## **Project Narrative**

### **Palm Lane Residences**

**412-PA-2024 Code: 84Z85**

### **3/15/25 Narrative Update:**

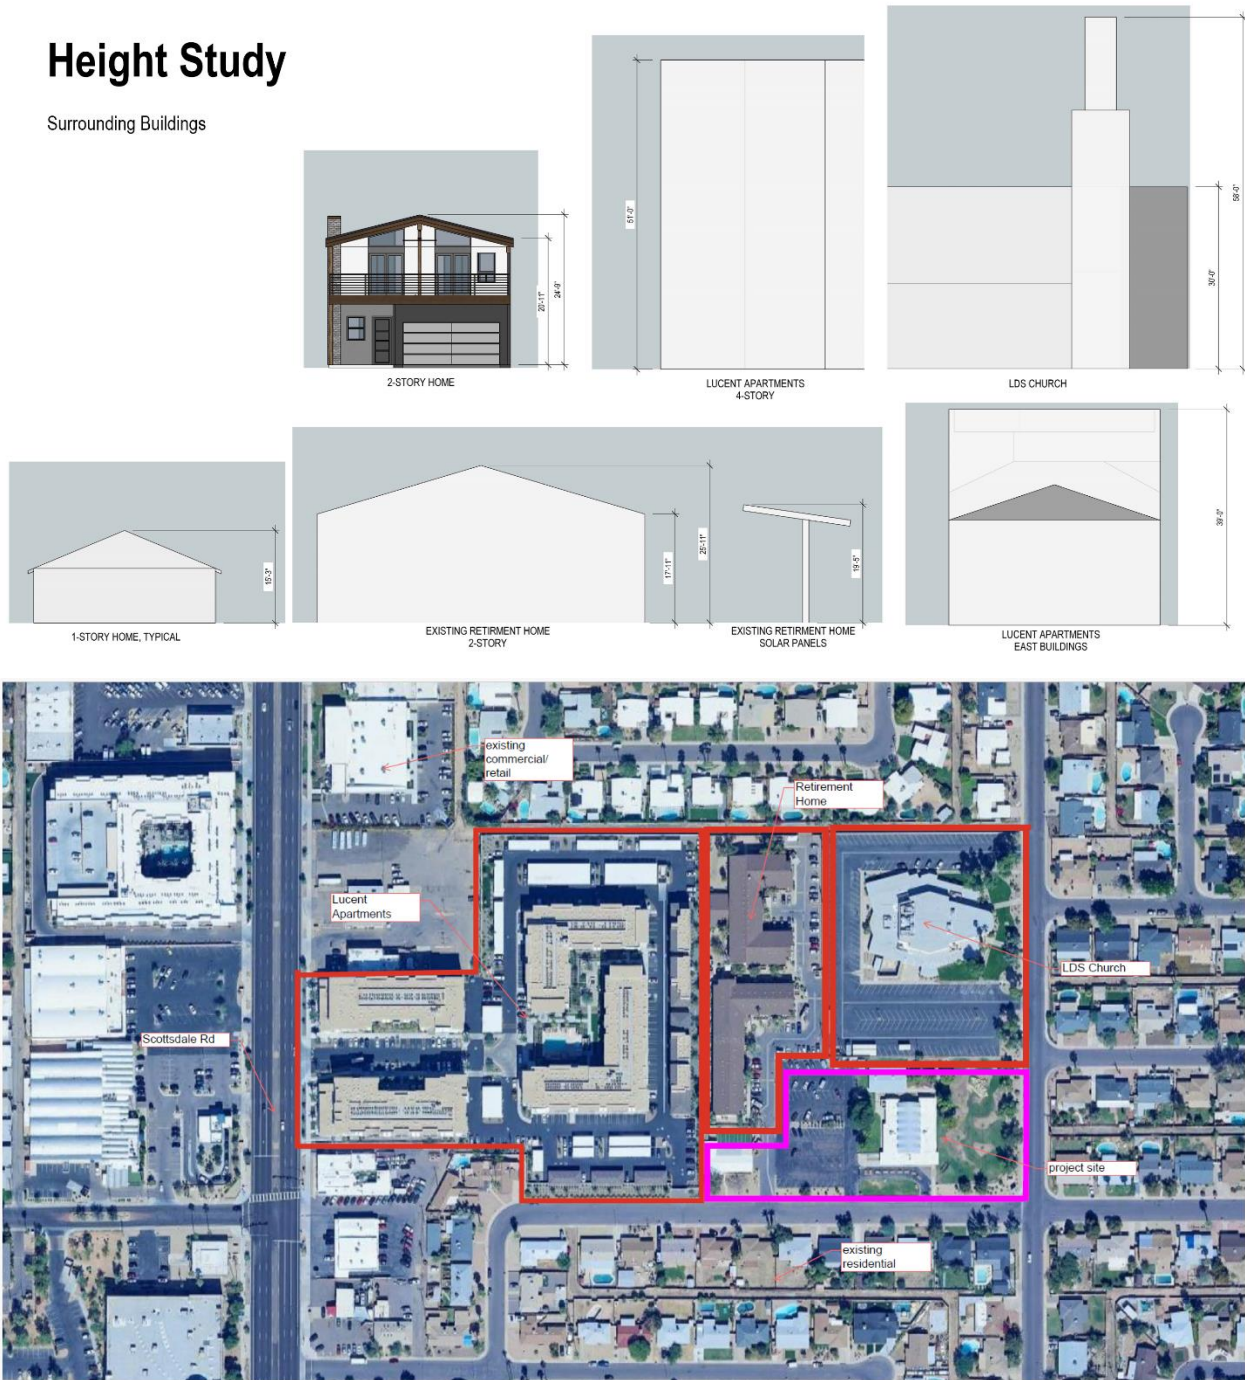
5. The proposed request is a zoning change from Single Family Residential (R1-7) to Medium Density Residential (R-3) zoning. Scottsdale General Plan 2035 designates the site as Suburban Neighborhoods, where densities are typically more than one dwelling unit per acre, but less than eight dwelling units per acre. The R-3 zoning district, if maximized, may permit up to 12 dwelling units per acre, which would not align/conform with the Suburban Neighborhoods land use designation but rather Urban Neighborhoods which typically allow for densities greater than eight dwelling units per acre. Please clarify within the revised narrative how the proposed development and change in density implements the definition of Suburban Neighborhoods as defined within the General Plan 2035 (Page 52).

**Response:** The proposed development has a density of 7.965 du/ac which is below the 8.0 du per the designation of Suburban Neighborhoods which is in compliance with the intent of suburban neighborhoods. The R-3 zoning allows us flexibility with the site layout to achieve an efficient and responsible site plan. Density Calculation below:

Large Lot 98,575 sf net (2.2631 ac) / 120,313 sf gross (2.7620 ac)

22 units/2.7620 ac = 7.965 du/ac
